ORIGINATION FORM

Proposed Revisions to a Standard Plans Index
(Please provide all information — Incomplete forms will be returned)

Index Number: 425-060
Sheet Number (s): 3 and 4 of 4
Index Title: Back of Sidewalk Drainage

INDEX SHEET
425-060 3 of 4

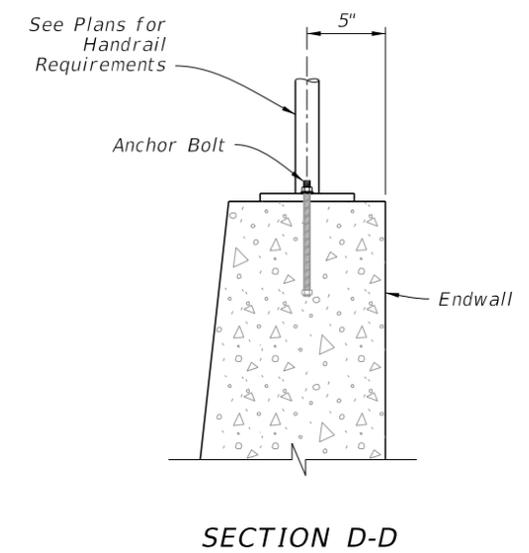
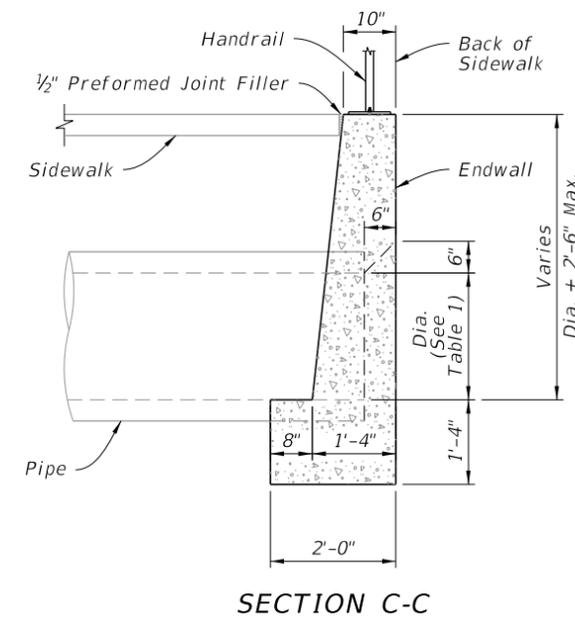
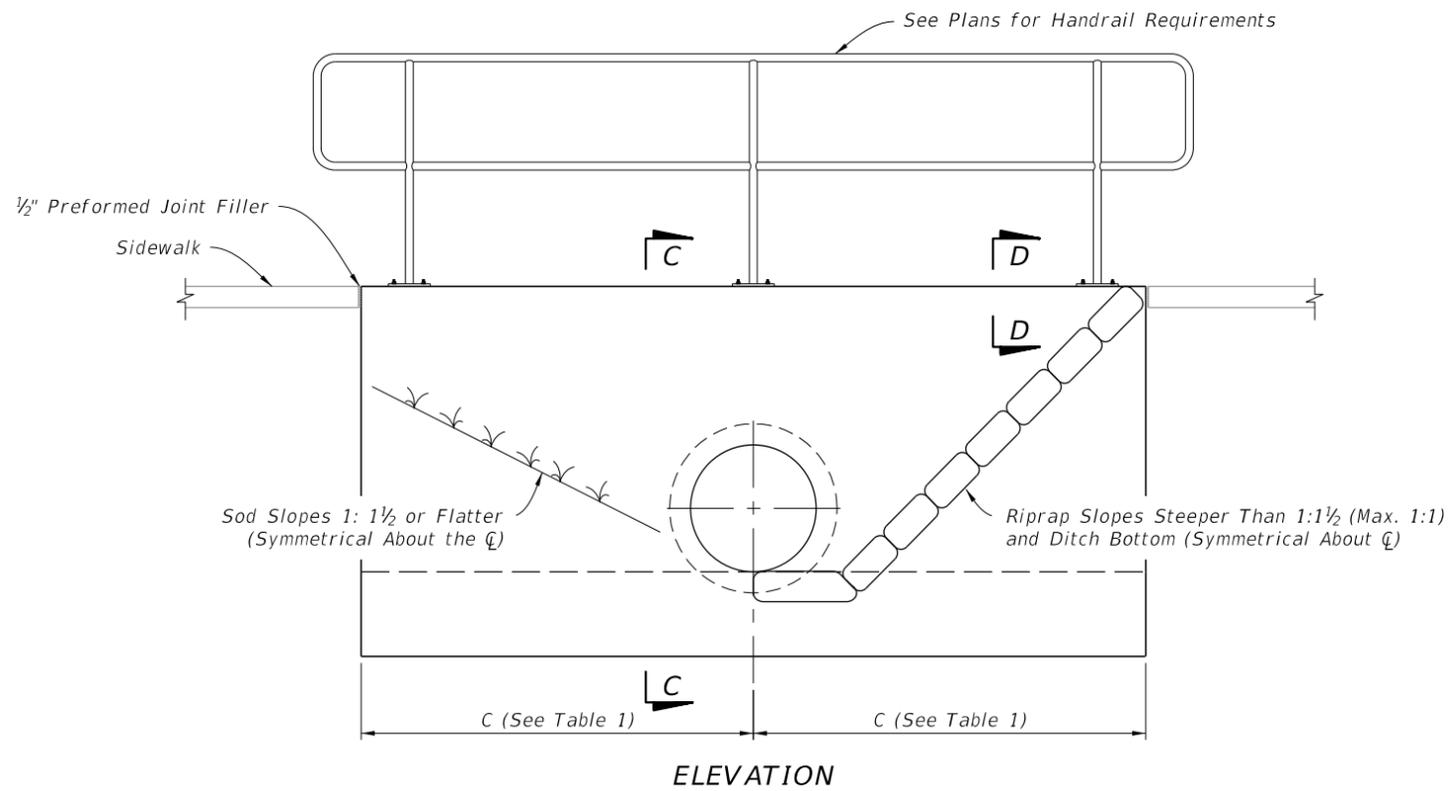
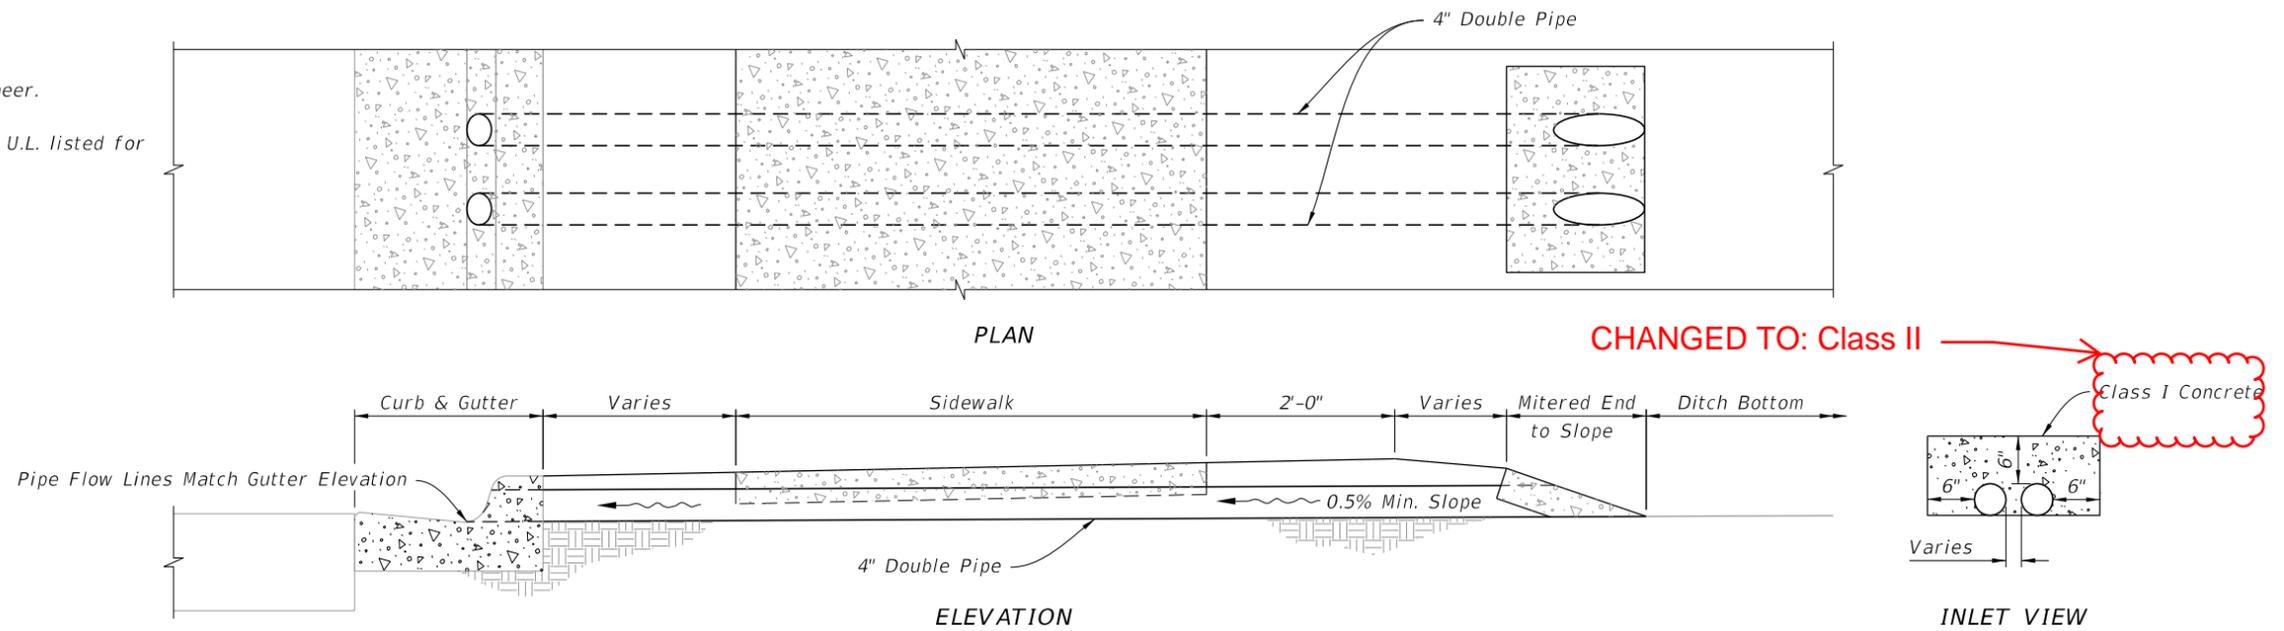
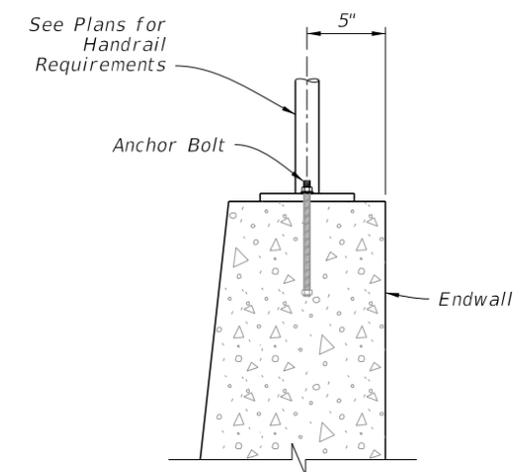
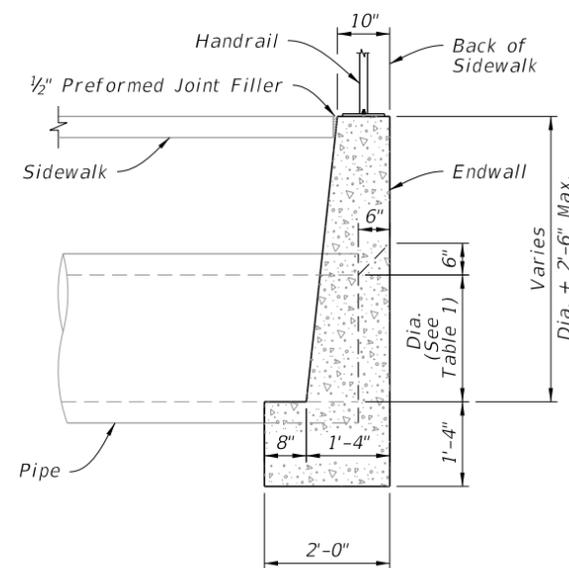
Sheet 3: Changed "Class I" to "Class II" in Table 1.

CHANGED TO: Class II

Pipe Size Dia. (in)	C	Concrete Class II (CY)	Sand-Cement Riprap (CY)
15	4'-9"	2.3	1.1
18	5'-3"	2.6	1.3
24	6'-3"	3.3	1.8

SHALLOW DITCHES AND YARD DRAINS

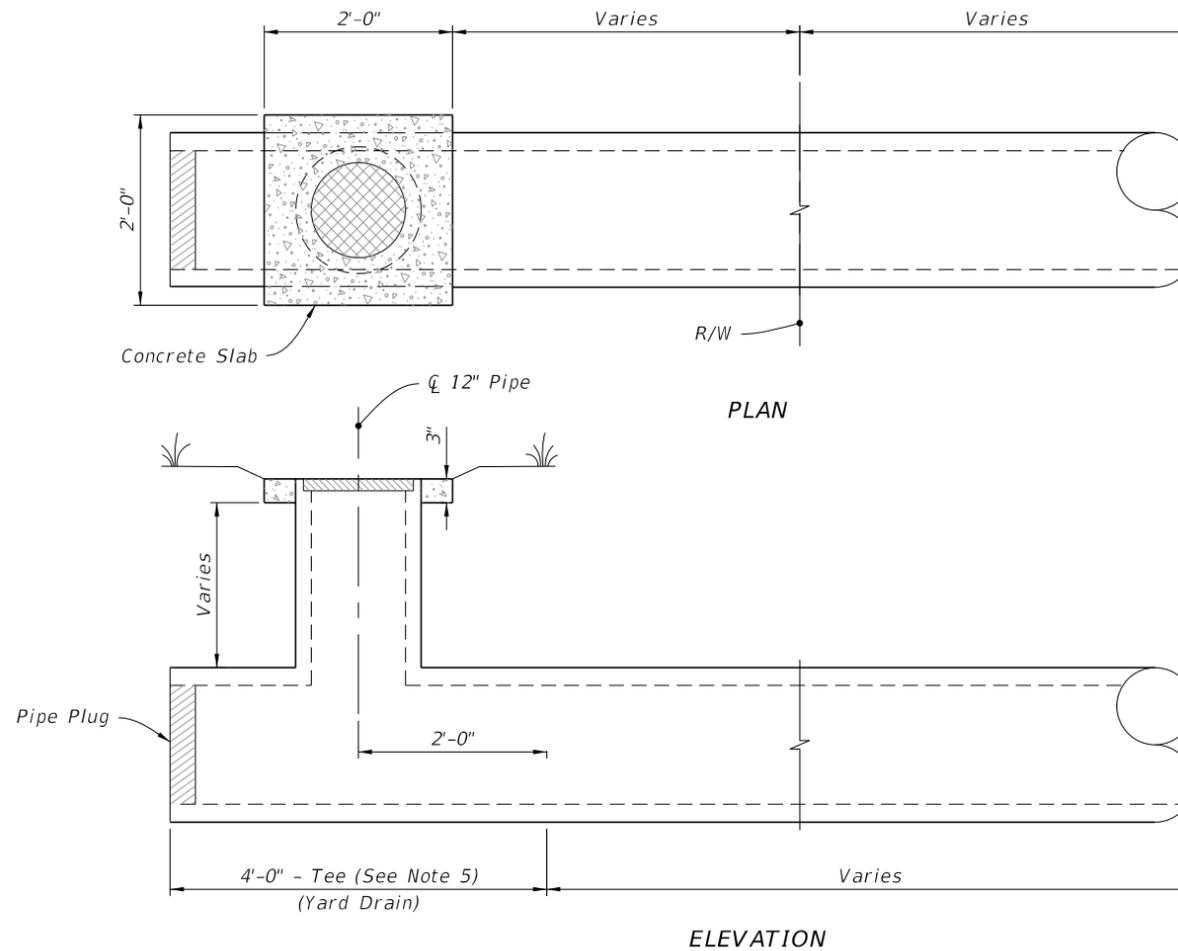
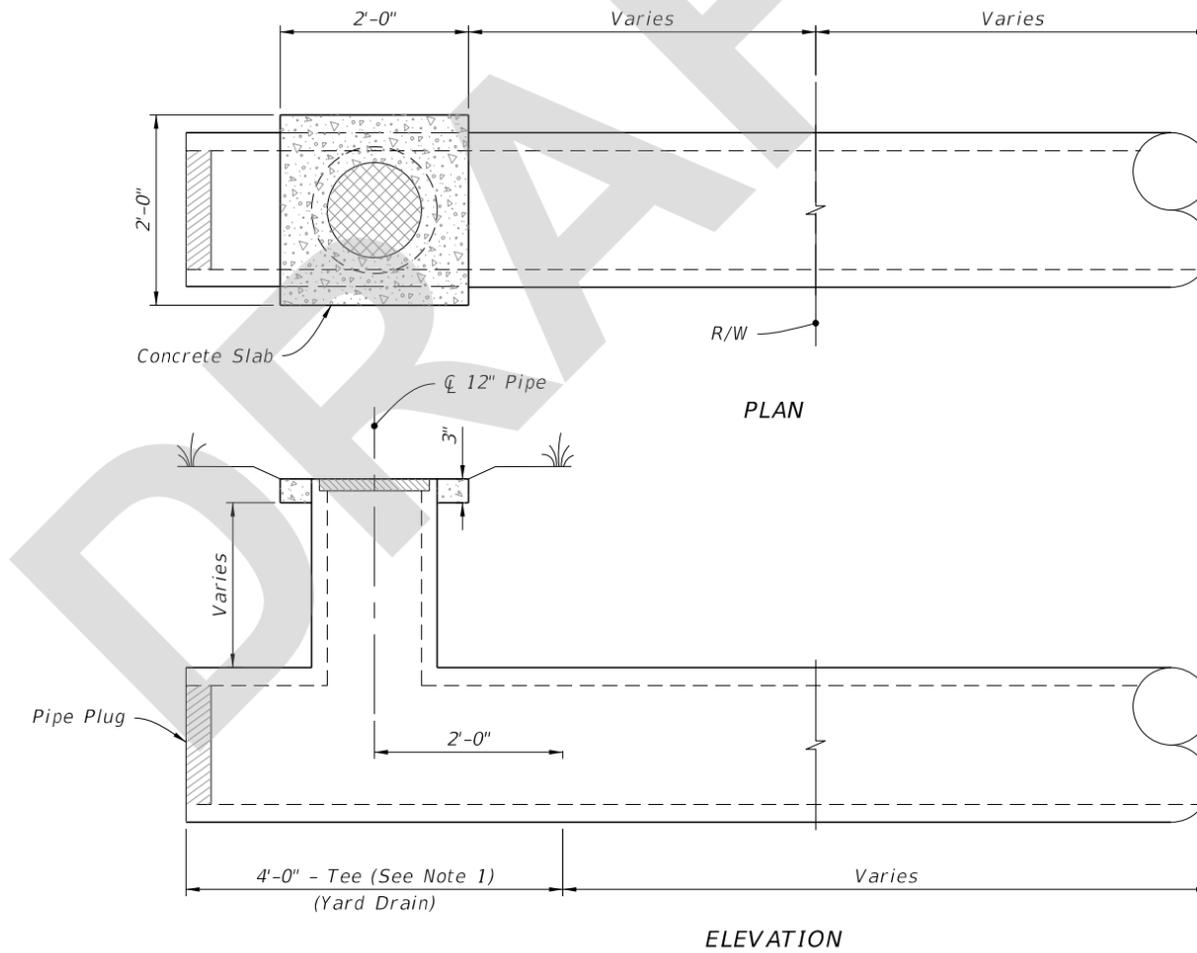
Sheet 4: : Changed "Class I" to "Class II" in the SHALLOW DITCHES - INLET VIEW detail.
